**Minor
Modification
Request**

**RE: Review of Request for Landfarm Minor Modification
T-n-T Environmental, Inc.
Permit NM1-008 (Evaporation Ponds and Landfarm)
Location: SE/4 of Section 7 and SW/4 of Section 8 (evaporation ponds) and the SW/4 SE/4
and SE/4 NW/4 of Section 5 and NE/4 NW/4 of 8 (landfarm), Township 25 North, Range 3
West, NMPM, Rio Arriba County, New Mexico**

RE: Land farm minor modification

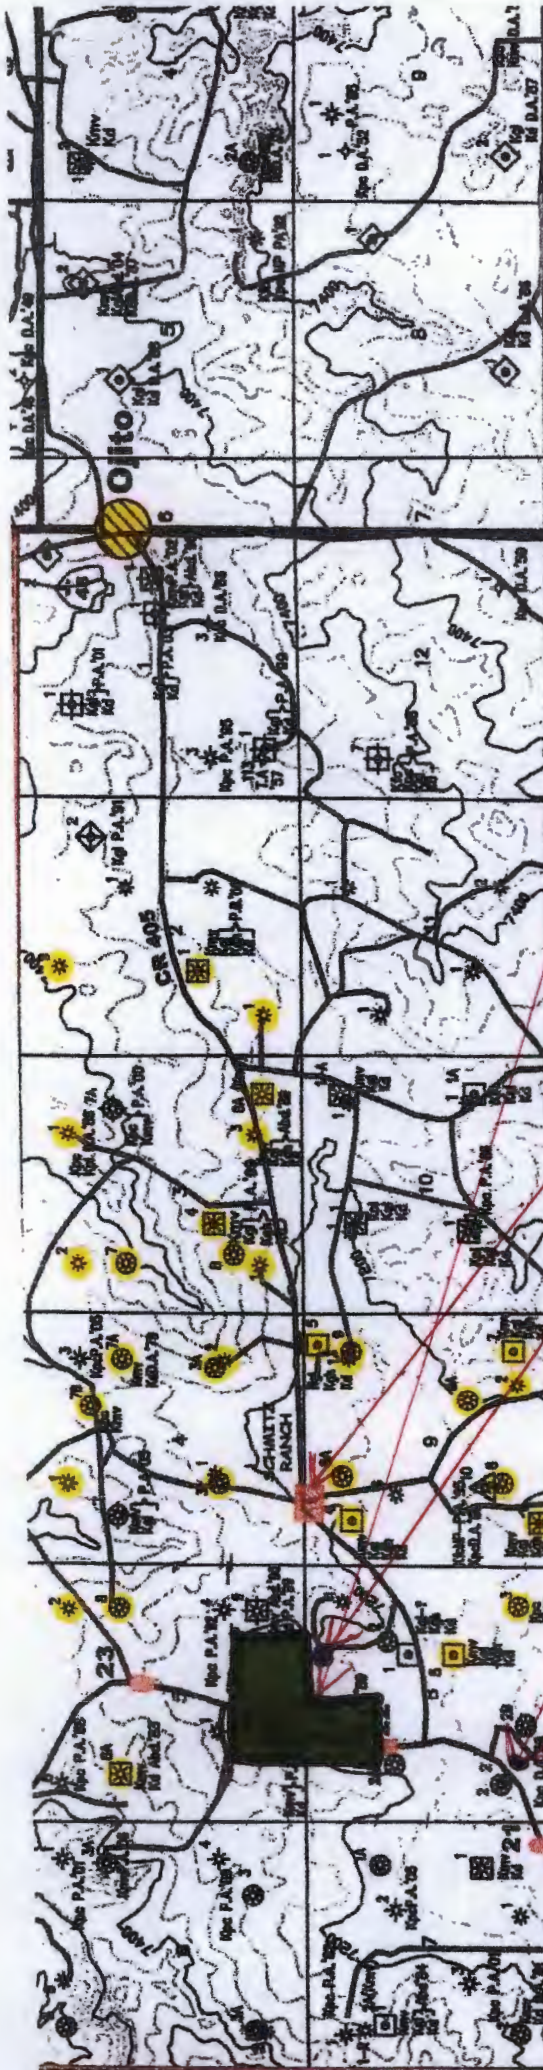
Section 10 of the permit application requires the applicant to “attach a description of the surface waste management facility with a diagram indicating the location of fences and cattle guards, and detailed construction/installation diagrams of pits, liners, dikes, piping, sprayers, tanks, roads, fences, gates, berms, pipelines crossing the surface waste management facility, buildings and chemical storage areas.” T-n-T’s response provided for Section 10 on the Form C-137 states “Attached.” A written description of “information that has changed from its last C-137 filing” regarding the surface waste management facility was not provided, but hand-drawn facility maps were. Please provide a written response that identifies “information that has changed from its last C-137 filing.” If facility maps or diagrams are utilized, please compare current operations and designs that have changed since the last C-137 was filed for each operation and/or design. The landfarm was permitted separately from the ponds. Each should have a separate C-137 filing.

HAND FARM MAP

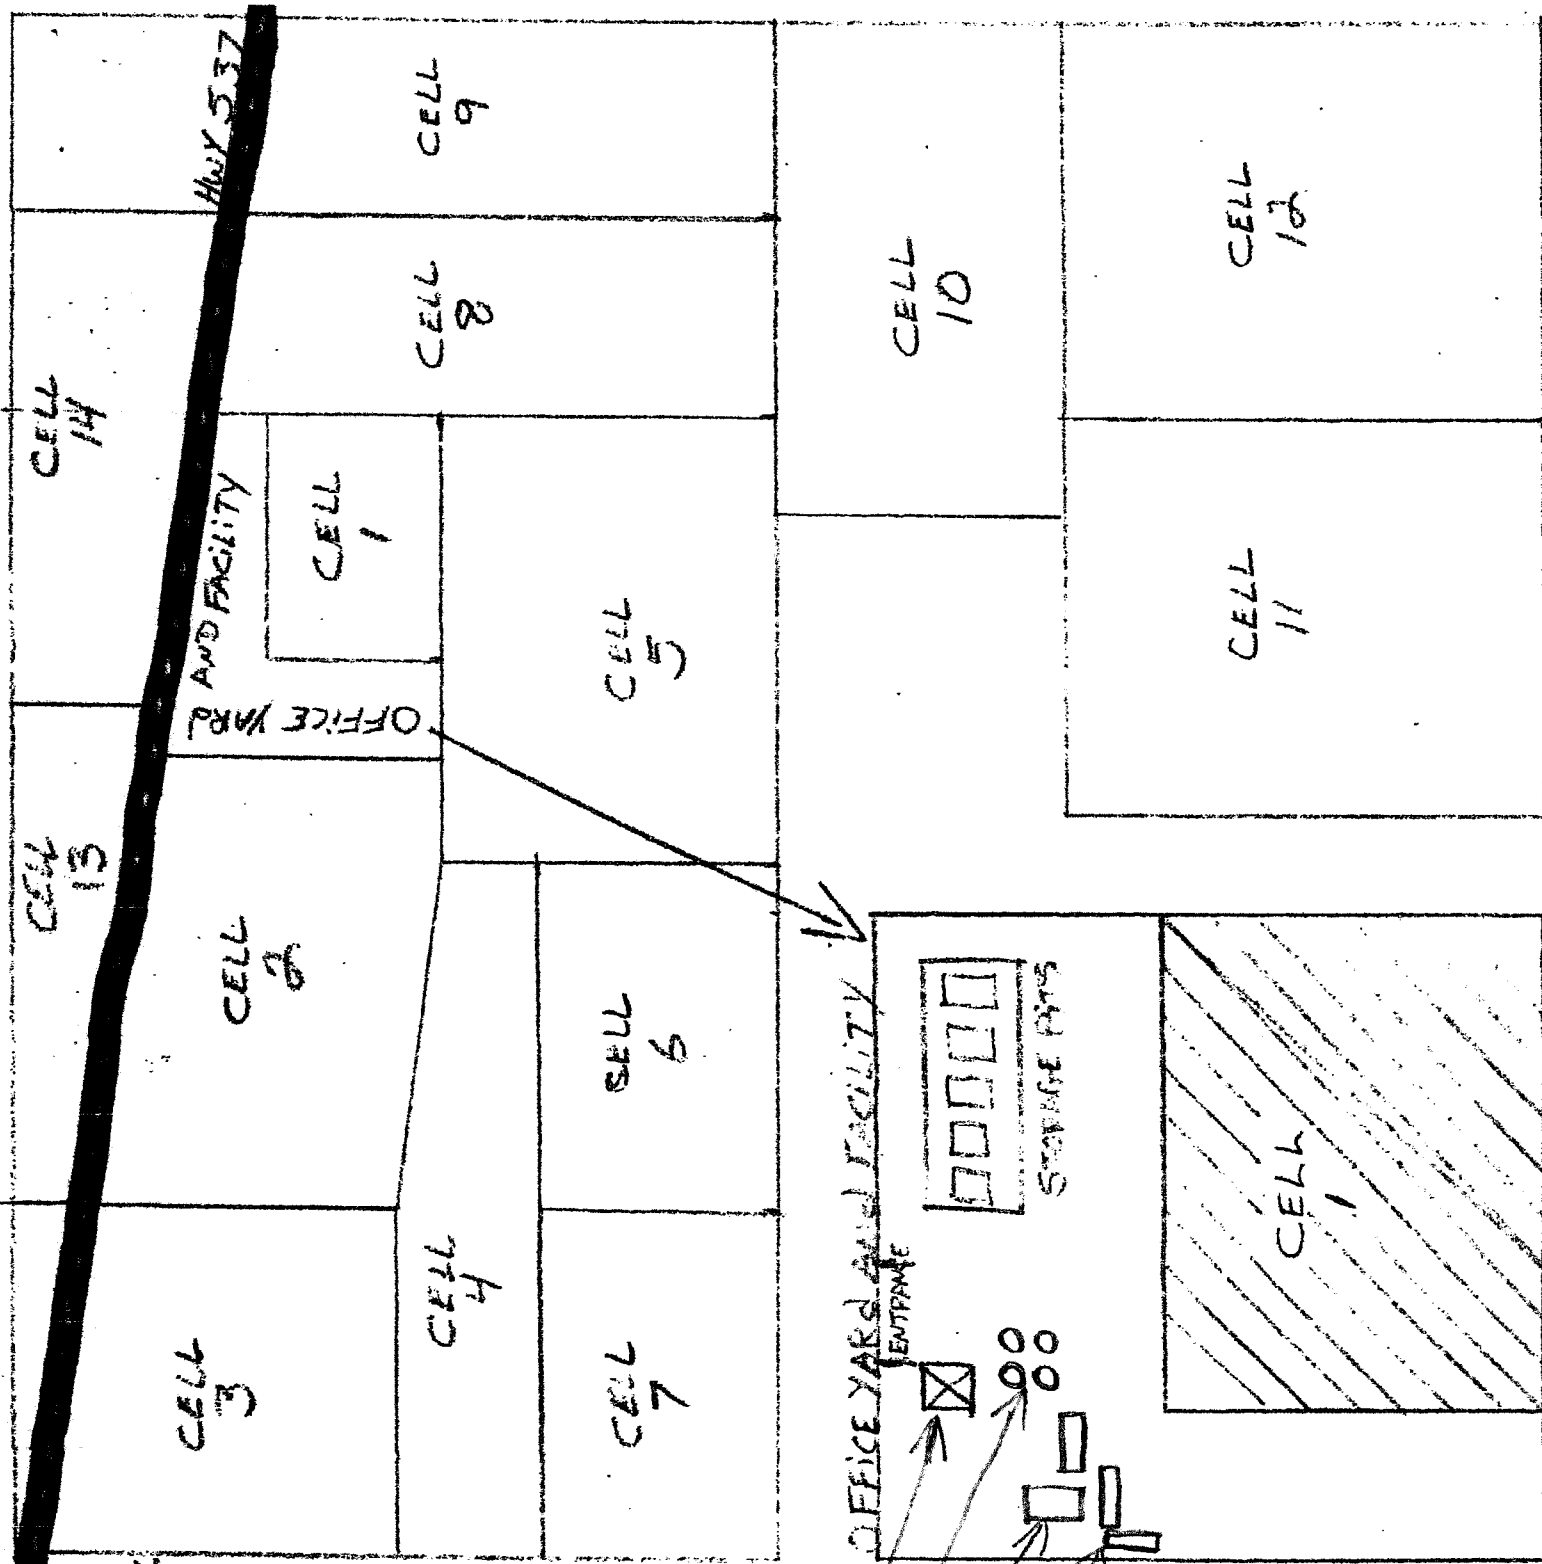
Section 8 of the Form C-137 (permit application) requires the applicant to "attach a plat and topographic map showing the surface waste management facility's location in relation to governmental surveys (quarter-quarter section, township and range); highways or roads giving access to the surface waste management facility site; watercourses; fresh water sources, including wells and springs; and inhabited buildings within one mile of the site's perimeter." T-n-T's response provided for Section 8 on the Form C-137 states "Attached." The only attachment that includes partially visible contour lines is a regional assessment of approximately 36 square acre area and is not site specific. The watercourses that intersect the landfarm are not illustrated on the topographic map. The area within the one mile assessment north and abutting Section 5 of Township 25 North, Range 3 West is not provided. T-n-T's response does not identify "information that has changed from its last C-137 filing." Please the complete one-mile assessment and provide a written response that identifies the "information that has changed from its last C-137 filing."
